Report on Consultation

Blarghour 132 kV Wind Farm Connection

May 2023

Figure 2.2
Route Options

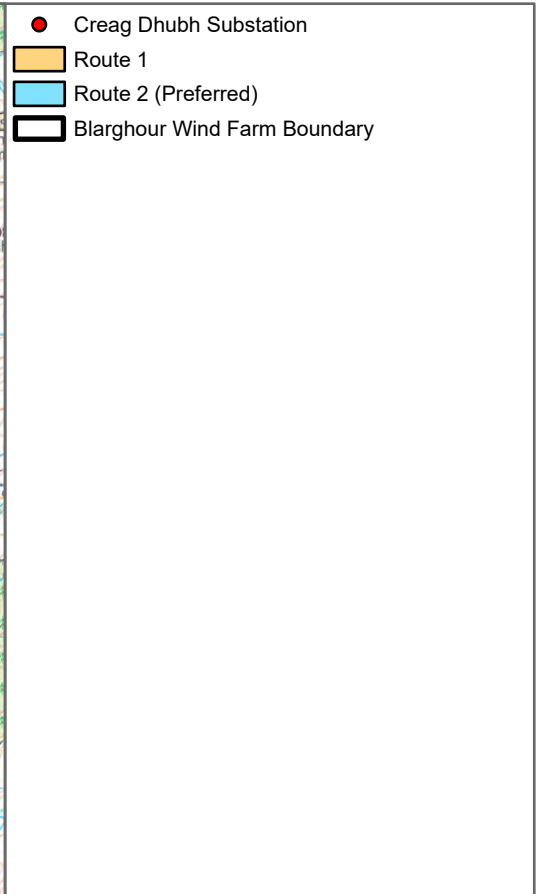
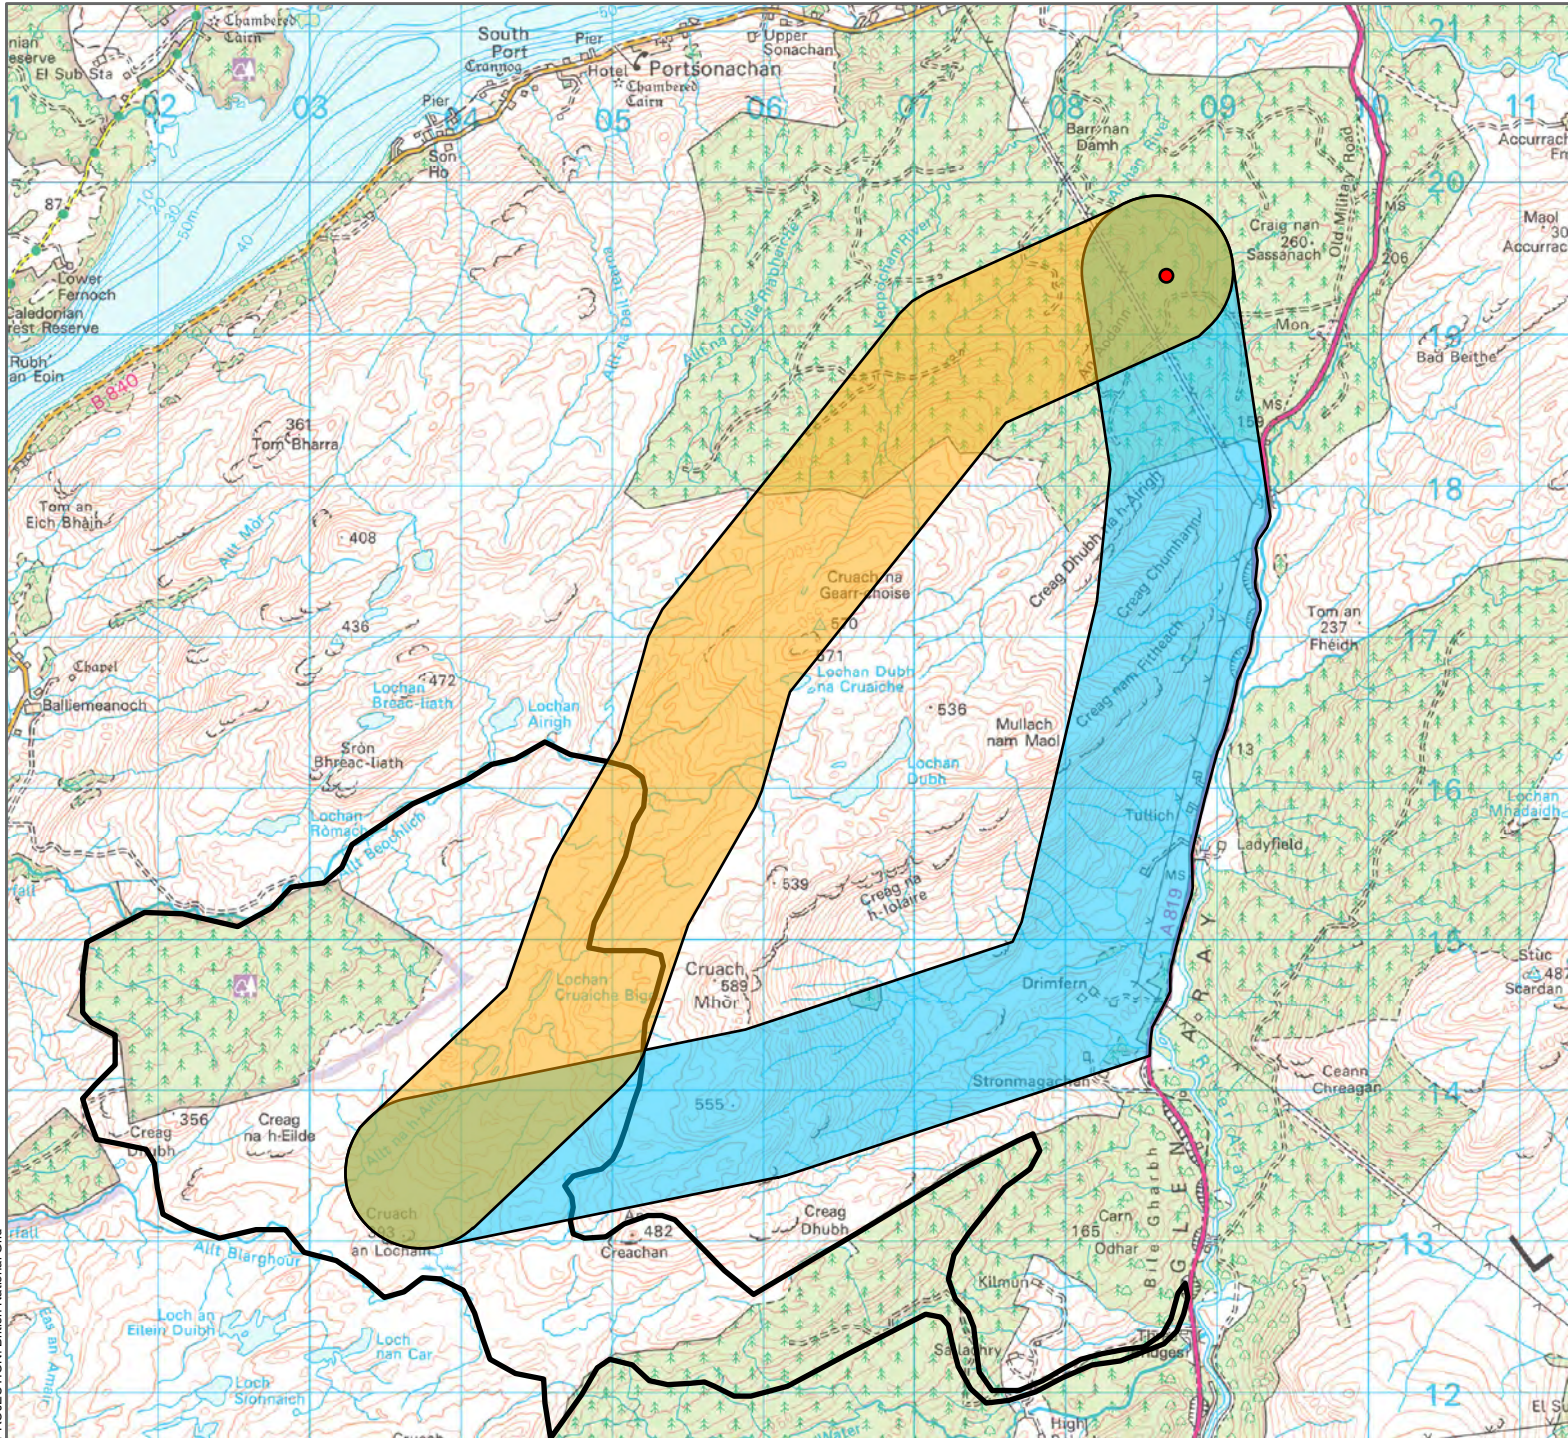
RSPB	<p>Cumulative Impact</p> <p>RSPB Scotland note that Route 2 overlaps with the proposed Creag Dhubh – Inveraray 275 kV OHL where it runs adjacent to A819 road. The Creag Dhubh to Inveraray project involves constructing nearly 9 km of new 275 kV OHL, supported by steel lattice towers, between proposed substation at Creag Dhubh and a connection point at Tower 18 on the recently constructed Inveraray to Crossaig OHL. Once the Creag Dhubh to Inveraray OHL is</p>	<p>SSEN acknowledges RSPBs comments in respect to ornithology and cumulative impact assessment. As part of the consents application an impact assessment will be undertaken to determine the likely effects of the Proposed Development. As part of this impact assessment in combination effects of this project and other local projects will be</p>

Forestry.Gov	<p>Following a review of the information provided it is noted that Route 2 is preferred, and that it overlaps with the proposed Creag Dhubh – Inveraray 275 kV OHL where it runs adjacent to the A819 road.</p> <p>Ancient woodland within the route corridor should be retained and all efforts to avoid impacting the woodland should be made by careful siting of infrastructure.</p> <p>It is advised that the UK Forestry Standard -4th Edition – 2017 (UKFS) and Scottish Governments Control of Woodland Policy 2009 (CoWRP) apply to the proposal.</p>	<p>SSEN acknowledges Scottish Forestry's response in respect to Ancient Woodland along the Preferred Route. SSENs policy is to minimise impacts on AWI and as such will work to microsite infrastructure away from such areas, where possible, using natural gaps in the woodland to minimise impacts on woodland integrity.</p> <p>SSEN the advisement of use of the UK forestry Standard and will consider this as the project progresses.</p>

Other Consultees		
Argyll Estate	A substantial proportion of the Blarghour Wind Farm Preferred Route (Route 2), as identified by SSE in the consultation document issued in May 2022, is located on land belonging to Argyll Estates, potentially in excess 80% of the route.	Whilst it is regrettable that Argyll Estates are hosting a large proportion of the infrastructure of this project, SSEN are very limited on the route of infrastructure for this project. Our assessment of routing options does not consider the number or identity of landowners.
	In development of the Preferred Route Argyll Estates note that SSE has considered only two routes and moved very quickly to selecting one of these.	<p>The alignment and access tracks have been developed in conjunction with landowners and occupiers since November 2021. Comments have been continually taken on board from all parties and inputted into our evolving design.</p> <p>A consultation period was held during May 2022, with a deadline for responses of 6th June 2022. A face to face public consultation event was held on Tuesday 18th and Wednesday 19th May and a</p>

<p>The analysis of Route 1 identifies the difficulty of gradient and mountainous terrain for routing, access and construction.</p> <p>No mention of the issue of steep or mountainous slopes appears in the engineering discussion for Route 2, despite the greater maximum and average gradients on Route 2.</p>	The remainder of this paragraph explains this statement further that a route with a maximum and average gradient of below 40% is considered to have low potential to constrain development. Gradients for Route 1 are given in the same paragraph. Gradients for Route 2 are given in Section 5.3.2 . The report therefore demonstrates that the topography of both routes are deemed to have low potential to constrain development.
	<p>For both Route 1 and Route 2 it is noted that</p> <p><i>“The landscape is likely settled with few residential properties and settlements”.</i></p> <p>In fact there are no residential properties or settlements along Route 1 (and reference to the closest settlement of Ardbrecknish is meaningless as that settlement is located over a hill, in a different glen and completely remote from the</p>	<p>Section 5.2.2 states that Route 1 has good clearance from any buildings, properties or communication masts.</p> <p>Section 5.3.2 states that Route 2 has four buildings / properties within the route corridor, which means it's far away from any residential properties.</p>

<p>Both route are identified as being approximately 9 km in length. However, on questioning SSE further, it appears the lengths are in fact (Route 1 - 8.02 km, Route 2 – 10.2 km)</p> <p>Route 2 is therefore 27% longer than Route 1, but the document indicates that both routes are of the same length. We believe this is very considerably misleading.</p>	<p>These are currently route corridors proposed in this consultation document. Depending on the alignment within this corridor, the route length can vary, hence it is difficult to provide route lengths at this stage but approximate lengths are given.</p>
	<p>Both routes are described as passing through</p> <p><i>“An area of open craggy upland / moorland Landscape Character Type within a medium / large scale landscape”.</i></p> <p>We do not consider that Route 1 does in fact pass through a craggy landscape, whereas Route 2 requires the line to pass over a very significant craggy area verging on being a cliff face.</p>	<p>As assessed by NatureScot, the areas are identified as defined in the consultation document.</p>

<p>Golden eagle is mentioned in relation to the potential of a barrier and collision impacts, but we would question whether this is relevant given the heights at which golden eagle fly and the significant impact that the wind farm itself will have.</p> <p>We believe that the corridor of Route 2 does not stand off 100m from the closest point of the Glen Etive and Glen Fyne SPA but in fact abuts the SPA. However, Route 1 is at least 1.5 km from the SPA (consultation document states 1 km, but it is at least 1.5 km on the basis that the connection will not extend beyond the Creag Dhubh Substation). As the northern section of the connection will be undergrounded, the proximity from Route 1 to the SPA is likely in fact to be at least 2 km.</p>	<p>The SPA sits on the other side of the A819, the exact distance from the SPA will be known at alignment stage. Likewise for Route 1, the exact distance will not be known until the alignment stage. The distances were intended to provide an estimate and illustrates that Route 2 is in closer proximity to the SPA than Route 1.</p>

<p>The consultation identifies that Route 1 was found to have 5% of the route within a 1 in 200 year flood zone which apparently "shows intermediate potential for development constraints due to flooding". Any developer proceeding beyond a very high level overview will require to carry out a flood risk assessment and these often reveal that the SEPA flood map is based on relatively broad brush contours. We do</p>	<p>Further surveys will be carried out at alignment stage but it is not feasible to carry out detailed surveys of the flood risk at this stage. The SEPA flood map is widely used as an indicator for flood risk and provides our best assessment at this stage.</p>
